Response to

Request for Additional Information No. 8, Supplement 1, Revision 0

U. S. EPR Standard Design Certification

Docket No. 52-020

Figure RAI 19.01-1-1—Comparison of SME and RLE for Rock Site (EURH)

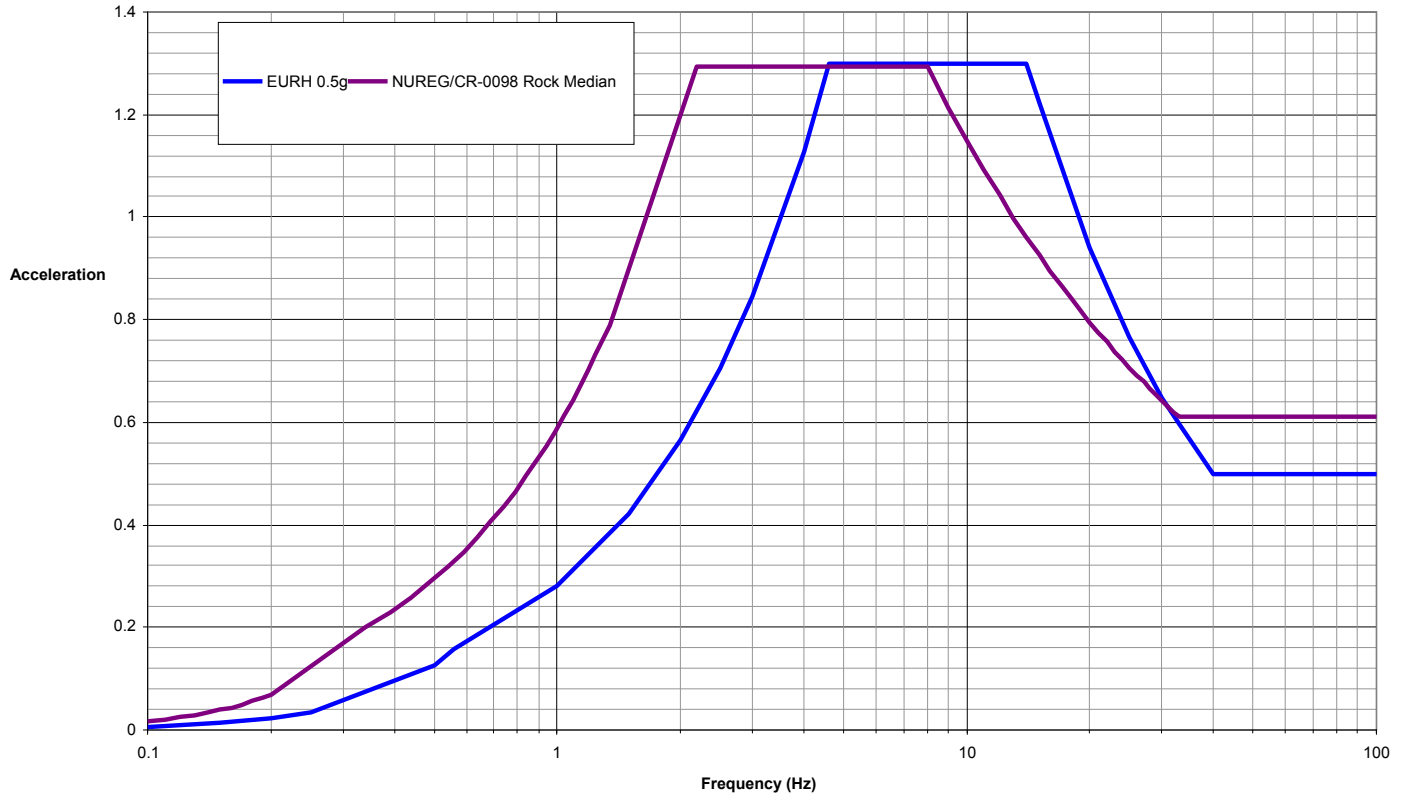
DCD, rev.0, Section 19.1.5.1.1 provides the seismic risk evaluation using a PRA-based seismic margin approach (SMA). As described in Subsection 19.1.5.1.1.2, the SMA was conducted in accordance with the NRC guidance in SECY 93-087 and a review level earthquake (RLE) was defined at 1.67 times the design basis SSE. The staff considers the Design Basis SSE as the certified seismic design response spectra (CSDRS) which includes the ground motion acceleration across the entire frequency range of interest. The staff also considers that the RLE is defined to be 1.67 times the SSE. The staff requests that AREVA incorporate the above staff position in the SMA assessment.

The median ground motion response spectrum for rock sites meets or exceeds the requirements for average spectral acceleration of 1.17g; and meets or exceeds the peak spectral acceleration of the EURH for the requirement of 1.67 times the CSDRS. The average spectral acceleration of 1.3g was selected, which corresponds to a peak ground acceleration (PGA) of 0.61g. This ground motion response spectrum shape was used in the fragility analysis and is shown in Figure RAI 19.01-1-1.

Figures RAI 19.01-1-1 and RAI 19.01-1-2 show the plot of the required 1.67 times the CSDRS, referred to as the review level earthquake (RLE), compared to the median NUREG/CR-0098 response spectra for rock and soil sites, referred to as the seismic margin earthquake (SME). For the rock case, the SME spectrum falls slightly below the RLE in the high frequency range. This does not impact the calculation of seismic margin of the SSCs for the following reasons:

Figure 19.1-8—Composite Containment Fragility Curve at 395°F 470°C

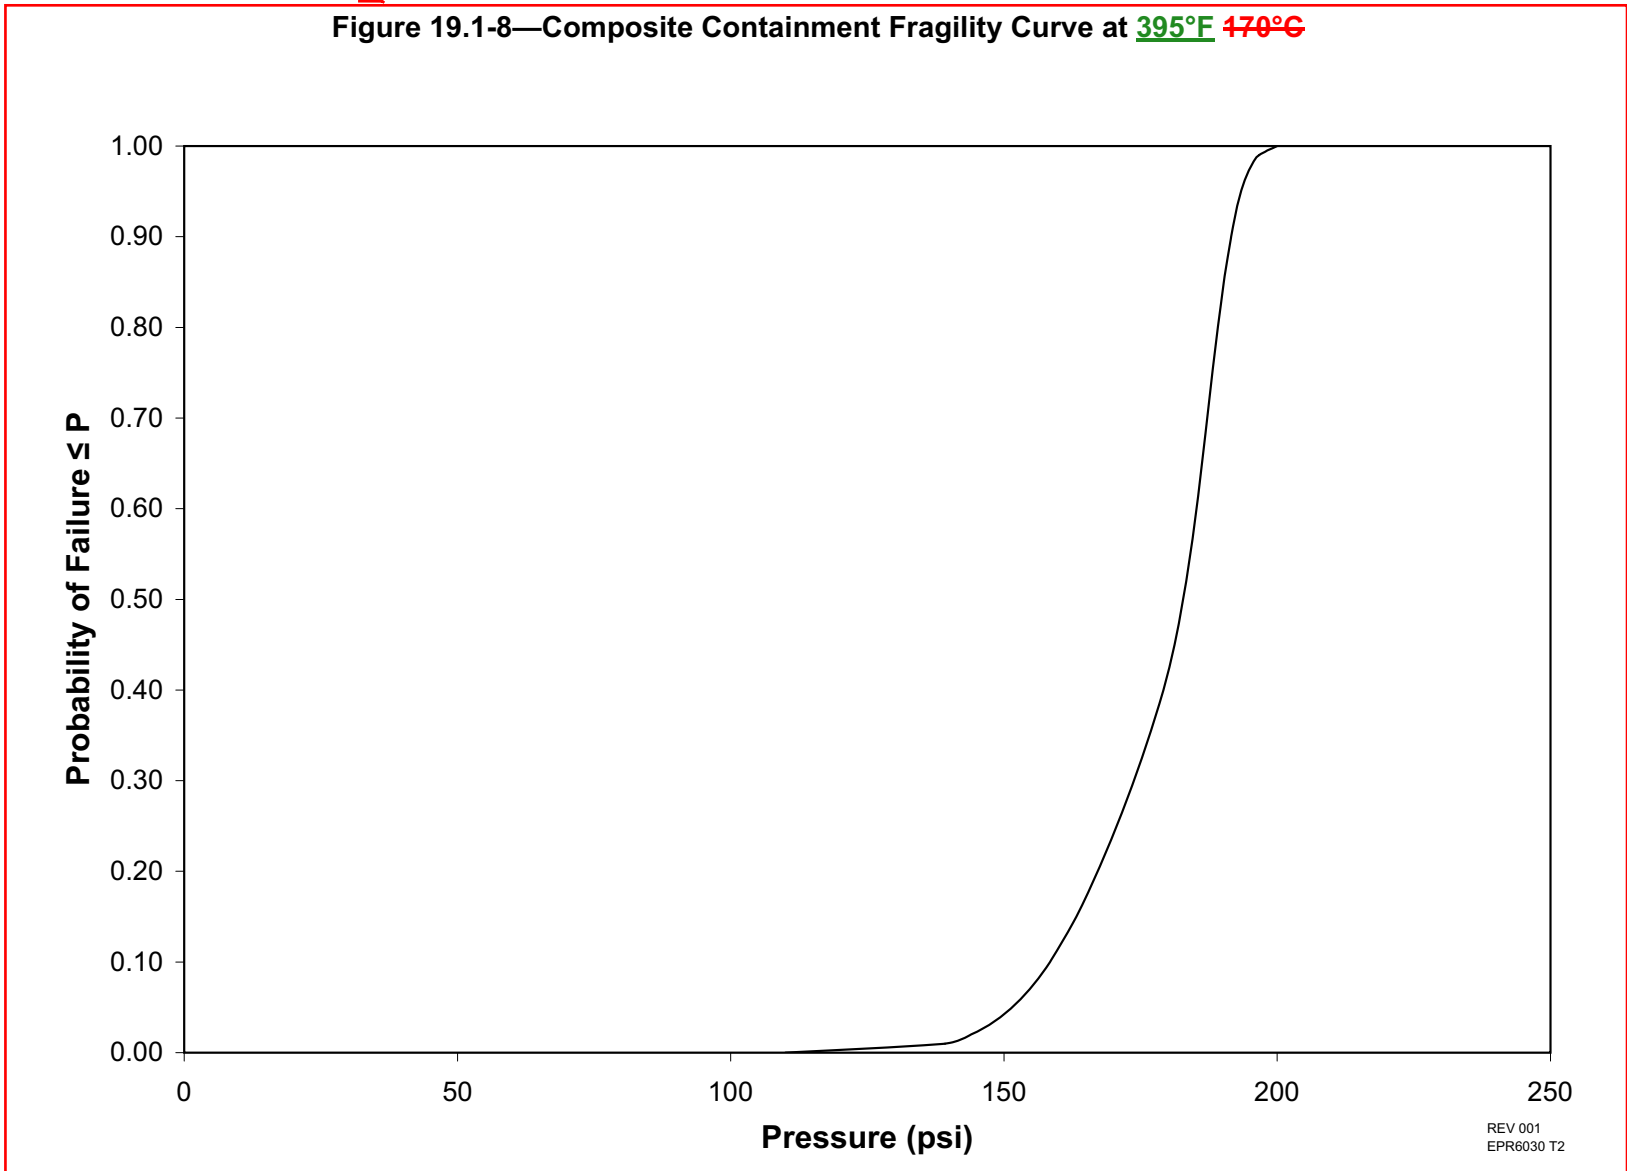
Section 19.1.4.2.1.3 of DCD Tier 2 Revision 0 provides a high-level description of the containment pressure fragility development. However, an in-depth description and associated data are needed by the staff in its evaluation. The staff requests that the applicant provide: 1) a discussion to justify that the fragility was only developed for the temperature 170 C(338 F), 2) a discussion of the analytical process for estimating the median capacity and the composite logarithmic standard deviation used to establish the fragility curve in Figure 19.1-8, 3) a discussion of the failure criteria and material limits based for the fragility development, 4) a discussion of the failure modes for the six failure locations identified in Table 19.1-21, 5) material data utilized in the fragility development.

The refinement to the calculation described previously has resulted in a change to the values in the U.S. EPR FSAR Tier 2, Table 19.1-21 and in the U.S. EPR FSAR Tier 2,

Figure 19.1-8. The updated values are shown in the attached revised U.S. EPR FSAR Tier 2, Table 19.1-21. The updated composite fragility curve is shown in the attached revised U.S. EPR Tier 2 FSAR, Figure 19.1-8.
